# **Harestanes South Windfarm Extension**

## **Environmental Impact Assessment Report Addendum**

### **Appendix A2 – Consultation with ECU (Ironside Farrar)**

### STAGE 1 CHECKING REPORT

SI Figure 6.5b: Peat Detail (Eastern)

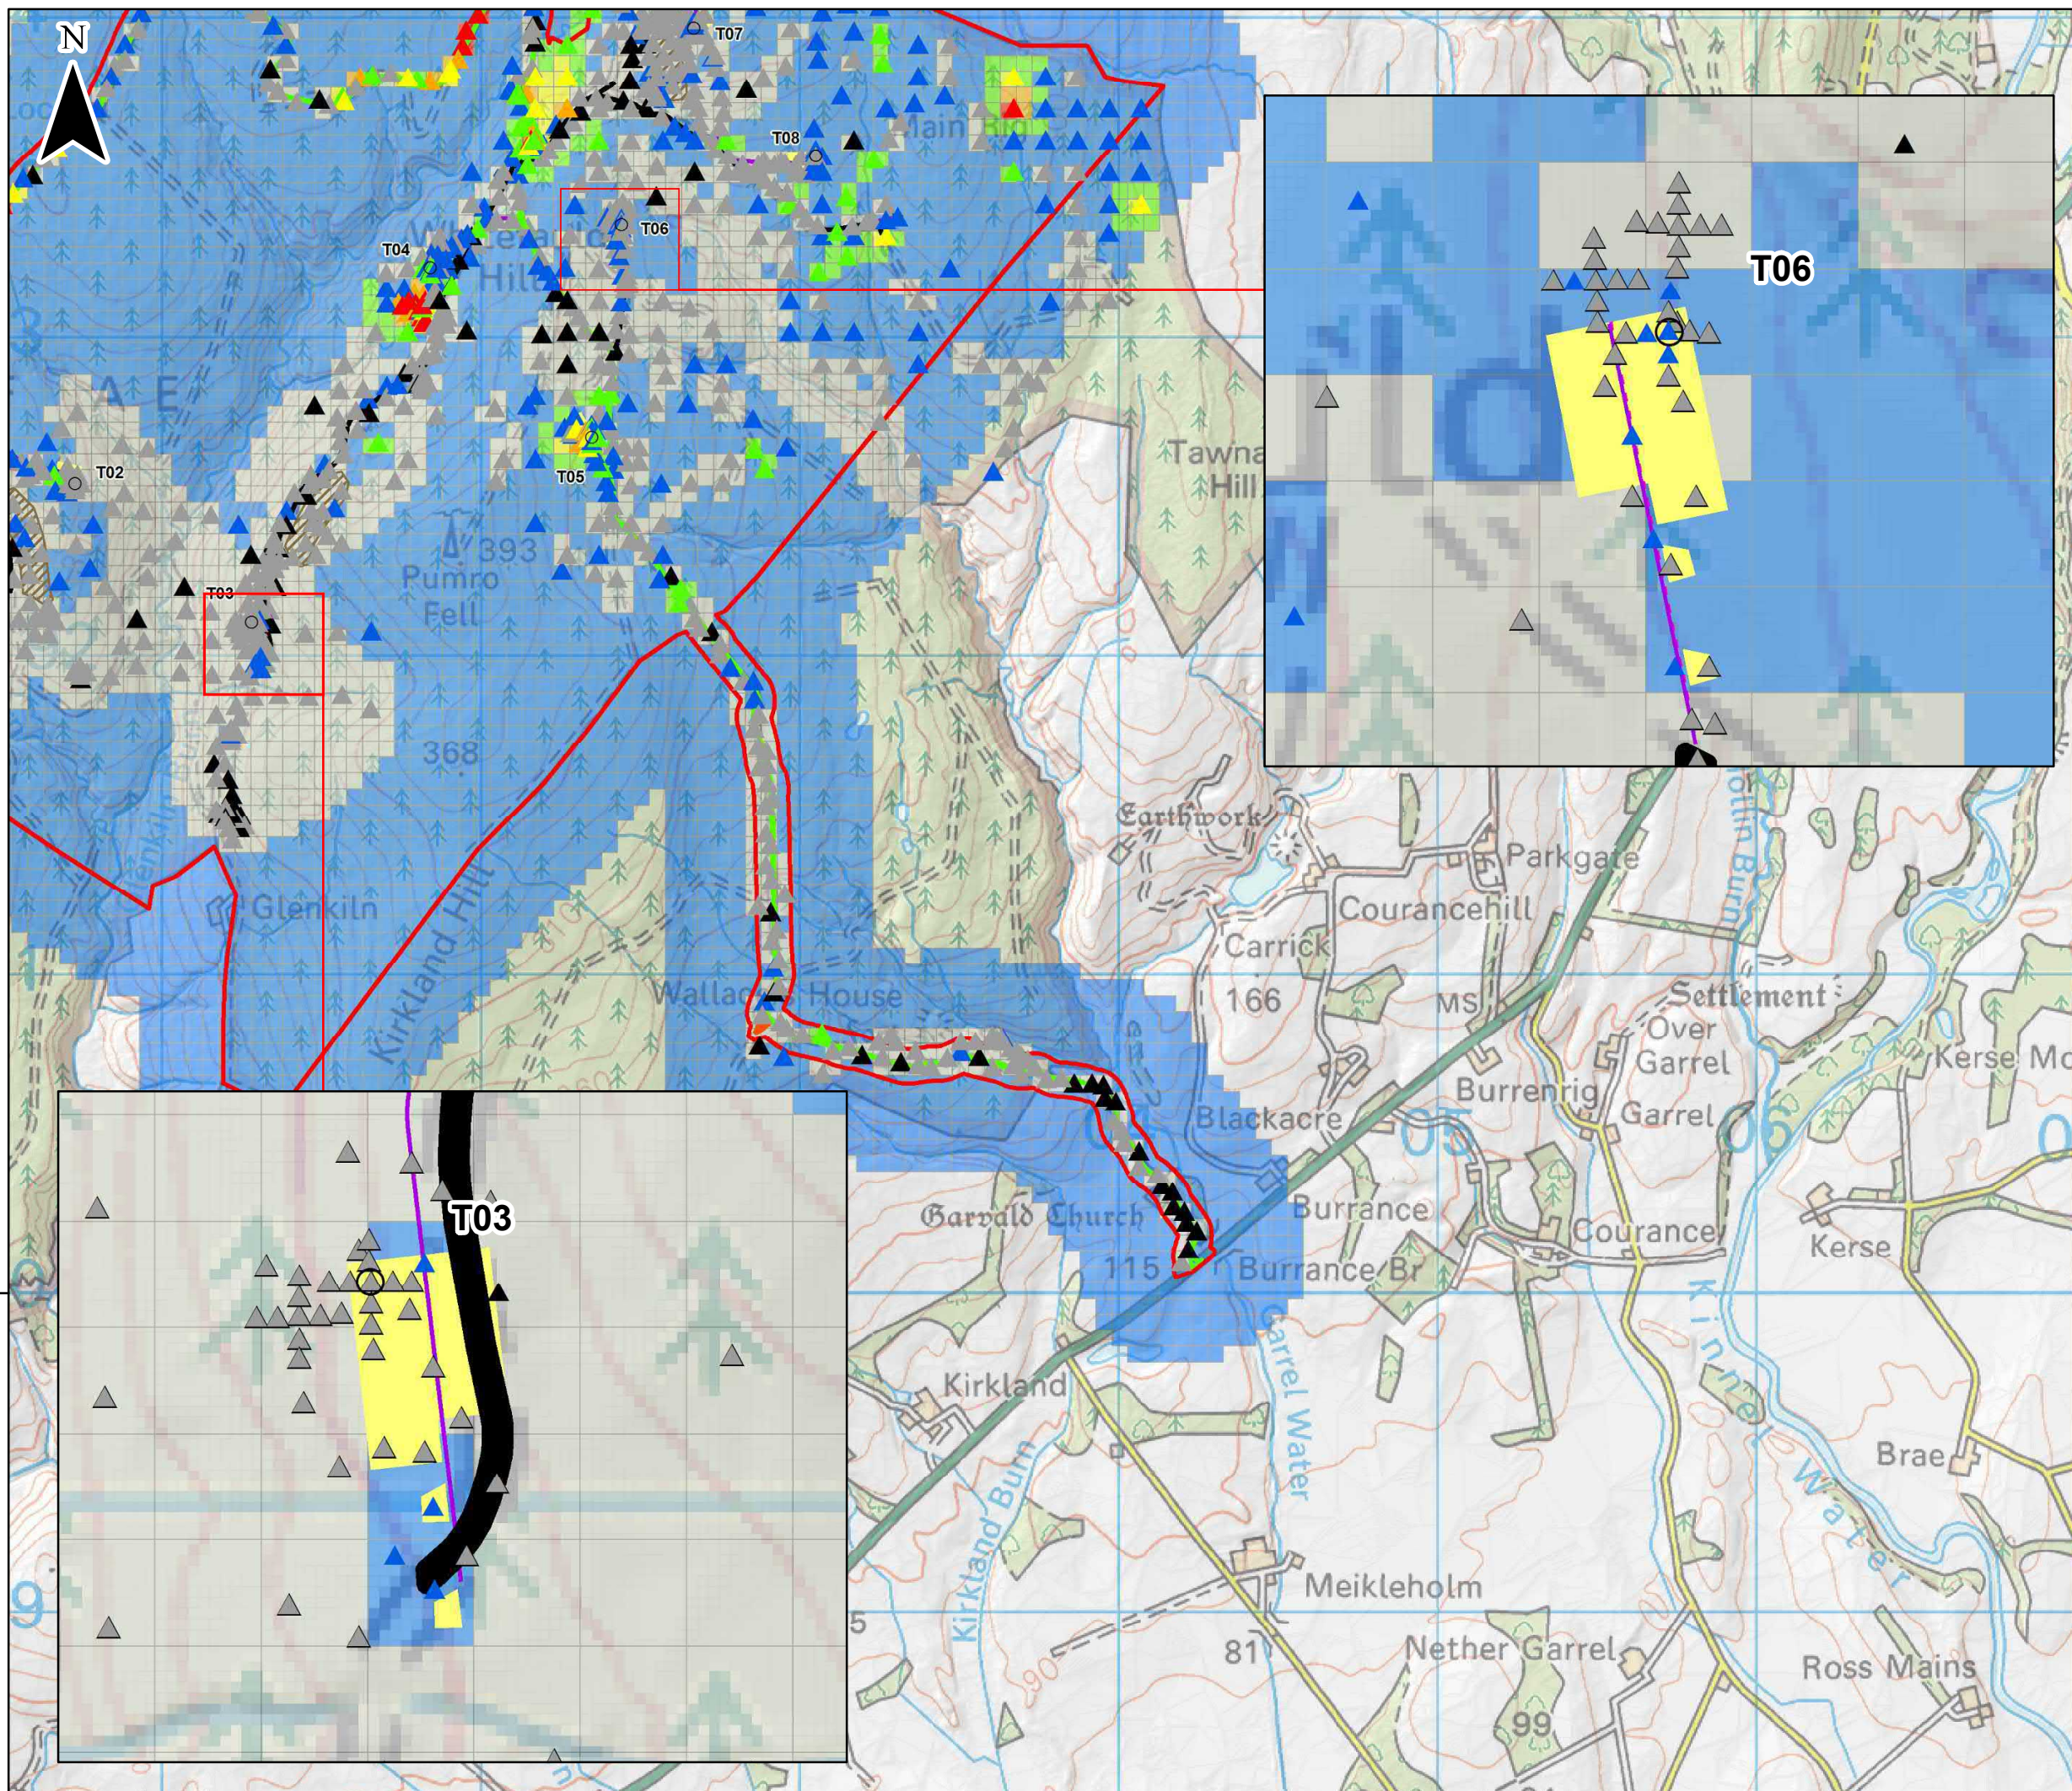
- Details are required on the probing density adopted for all infrastructure including turbines and how this aligns with the SEPA/ ECUBPG.
- The lack of a Phase I site wide peat probing survey is a significant short coming in the report, and a deviation from the ECUBPG. Clarification is required as to whether the lack of site wide probing has affected the robustness of the assessment. It is not clear how the peat depths presented on large parts of the peat depth mapping have been generated without probe information. This has raised some concern as to whether the peat depths presented on the mapping are sufficiently supported by site data and in turn are sufficiently representative of the overall picture of peat on the site. This inevitably has the potential to affect the risk assessment and its outcomes. Whilst it is appreciated that some of these areas will not be in influence of the proposed infrastructure, it is ensuring that areas that are within influence, have been adequately assessed, e.g. upslope and downslope locations of wind turbines, tracks etc.

*Details are required on the probing density adopted for all infrastructure including turbines and how this aligns with the SEPA/ ECUBPG.*

*Ironside Farrar requested 'further explanation is required as to how peat depths have been arrived in areas of the site that do not contain any specific peat depth data and whether the depths presented on the mapping are therefore accurate and sufficiently representative to take through the risk assessment'.*

The enclosed Peat Overview and Detail SI Figures 6.5 a – d show the probing density within the Proposed Development.

A presentation error on the EIA Report Peat Overview and Detail Figures was noted, the peat depths surveys results were shown as an interpolated map (using Simple Krigging method) rather than a 50 m grid, as explained in Technical Appendix 6.1. This error does not alter the assessment results; however, it has been amended on the enclosed Peat Overview and Detail SI Figures 6.5 a – d to be consistent with the methodology explained in Technical Appendix 6.1.
